**OFFICIAL COORDINATION REQUEST FOR  
NON-ROUTINE OPERATIONS AND MAINTENANCE**

**COORDINATION TITLE-** 14 LGS 11 Re- Installation of cooling water discharge valve pipes per NPDES

**PROJECT-** Little Goose Project

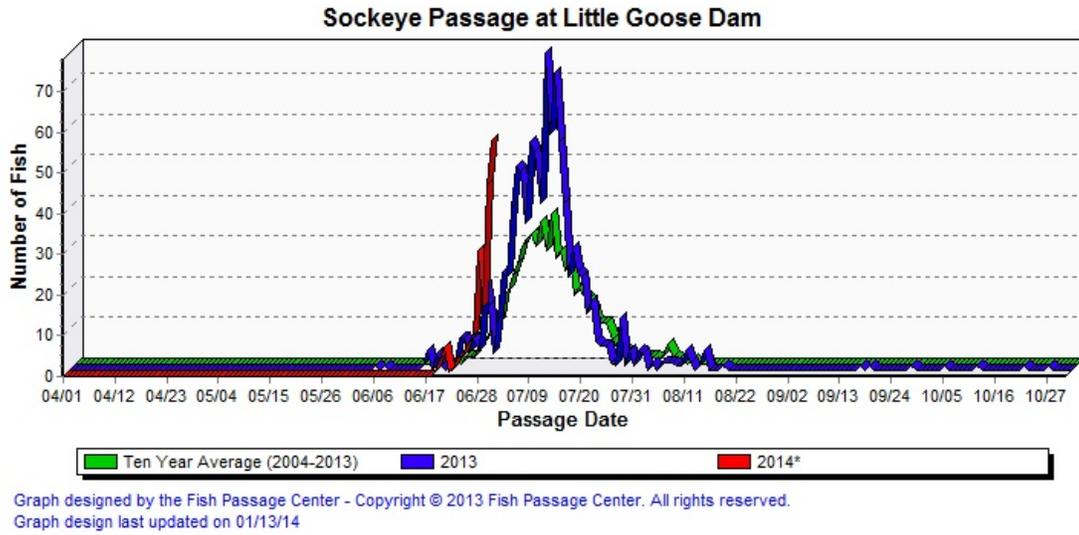
**Expected impacts on fish passage-** Unit #1 will be off for 2 hours and will reduce attraction to south shore adult ladder entrance. While unit 1 is off unit 2 will be running to reduce impact. Below graph shows we are at a low point in adult returns and should affect a small number of Chinook if unit #1 is off for 2 hours. Adult fish counters report 1300 to 1400 as the slowest hour for fish climbing the ladder at this time of year. We will have unit 1 off during this time period. The average hourly chart below shows that the best time to do units 1, 2 is between 1300 and 1600 hrs and will have the least impact on fish passage. This is the time of day we will rotate through units 1, and 2.

Sorry this is past deadline I was on vacation but I had a question, the document states "Below graph shows we are at a low point in adult returns and should affect a small number of Chinook if unit #1 is off for 2 hours" However, the graph shows that we are entering the peak of migration and we should be at about the highest point in adult sockeye returns. Why doesn't the impact analysis discuss sockeye? Thanks,  
Sheri

No diurnal sockeye passage chart available at this time as website is not responding
